A1 in Northumberland: Morpeth to Ellingham

Scheme Number: TR010059

Annex B - Flood Risk Assessment Addendum

Regulation Reference:	APFP Regulation Rule 8(1)(b)
Planning Inspectorate Scheme Reference	TR010059
Application Document Reference	TR010059/7.9.1.2
Author:	A1 in Northumberland: Morpeth to Ellingham Project Team, Highways England

Figure 1 - Overview of original proposals on the River Coquet

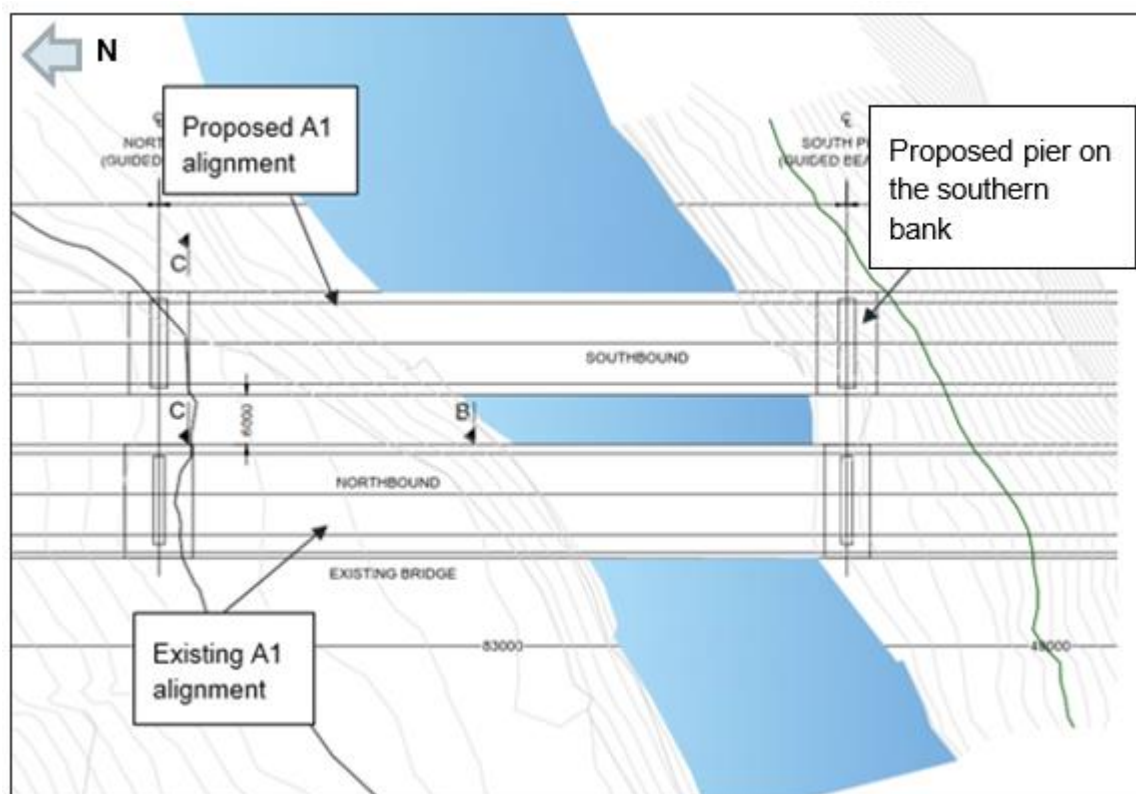
- 1.1.2. The FRA (**Appendix 10.1: Flood Risk Assessment Part A [APP-254]**) investigated the potential impacts of the new piers on water levels using a Manning's assessment. The Manning's Equation calculates flow velocity and flow area within an open watercourse channel, and in turn can be used to determine changes in flood depth as a result of changes in cross sectional width. The assessment was undertaken using an indicative water level estimated to be equivalent to the 1 in 1000 year event. The assessment indicated that only the southern pier would interact with this flood extent.

- 1.1.3. The power of deviation contained in the draft Development Consent Order results in the potential for the piers to be offset from the locations assessed within the FRA as outlined in Parameter 10. The potential range of locations is illustrated in **Appendix A** and detailed below:

- The northern pier could move up to 6 m to the north (from the current proposed location) with an allowance to move the pier by a further 2 m in any other direction. This is equivalent to a movement range of between 0 m and 6 m to the north of its current location.

- The southern pier could move up to 2 m to the north (from the current proposed location) with an allowance to move the pier by a further 2 m in any other direction. This is equivalent to a movement range of between 0 m and 2 m to the north of its current location.

Figure 2 - Cross-section of River Coquet at bridge location based on 1 m LiDAR

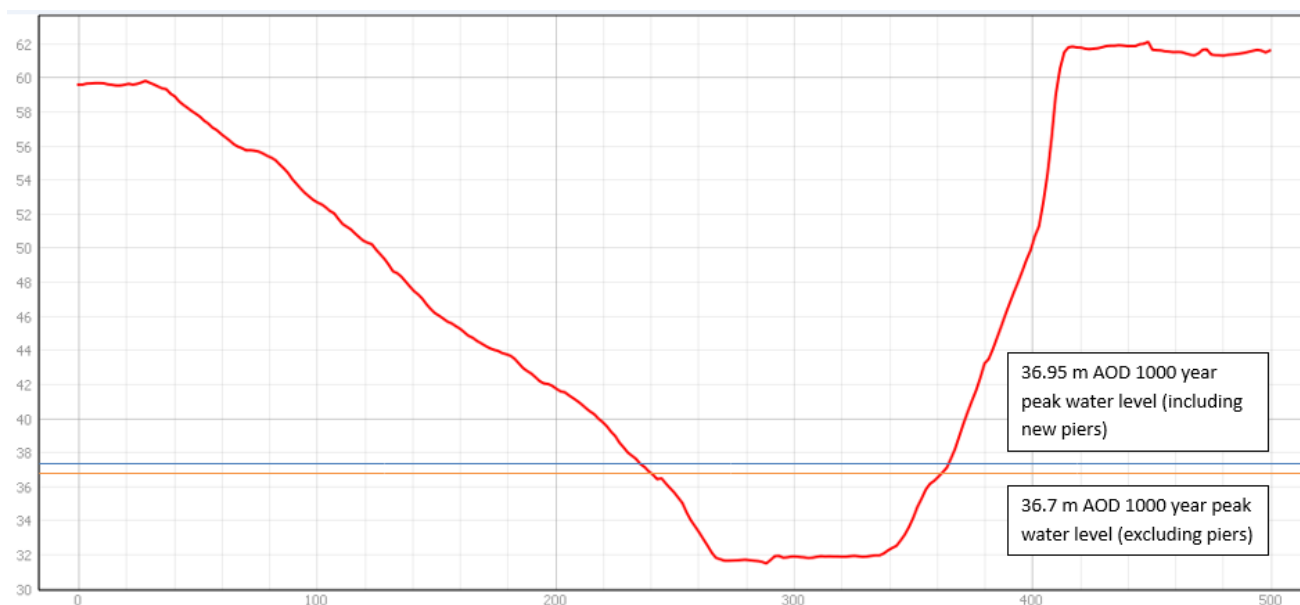
- 2.1.1. The proposed movement of the northern pier would take this structure further away from the predicted 1 in 1000 year flood extent than currently proposed. **Figure 2** below shows the predicted 1 in 1000 year flood extent in relation to the available 1 m LiDAR data. The original location was assessed to be outside the 1 in 1000 year flood extent and as such the proposed new location would also be outside of this extent. As such no further consideration of this pier with respect to flood risk is required.

- 2.1.2. The potential movement of the southern pier would take this structure further towards the river channel and potentially within the estimated 1 in 1000 year flood extent. Assuming the location is moved the maximum 2 m to the north, the adjusted location of the pier would move the base of the pier to a minimum elevation of approximately 33.1 m AOD at its upstream end. It is assumed that the pier would extend onto higher ground at its downstream face as previously proposed and therefore follow a similar alignment to the existing pier as illustrated in **Figure 1**. This in effect could potentially block flood flows through the southern extent of the floodplain from 33.1 m AOD.

- 2.1.5. Removing the right bank area of the cross section from 33.1 m AOD and again completing a Manning's calculation indicates a revised peak water level of 36.95 m AOD in a 1 in 1000 year flood event; 0.25 m higher than the baseline peak water level estimated above.

- 2.1.8. Review of 1 m LiDAR data, as shown in **Figure 2** below, indicates that an increase of 0.25 m would remain several metres below the top of the river valley on either side (with an estimated elevation of c.59.8 m AOD at this location) and therefore does not impact any identified flood risk receptors. The estimated increase of 0.25 m is expected to be a localised increase that would not extend a significant distance upstream of the proposed structure.

- 2.1.10. The updated assessment demonstrates that a change in the alignment of the piers along the River Coquet would still have a localised effect that is not considered to extend a notable distance upstream or downstream of the proposed piers and is not predicted to increase flood risk to identified receptors. On this basis it is concluded that the findings of the FRA (**Appendix 10.1: Flood Risk Assessment Part A [APP-254]**) submitted to support the DCO with respect to flood risk from the proposed works on the River Coquet have not changed and remain valid.
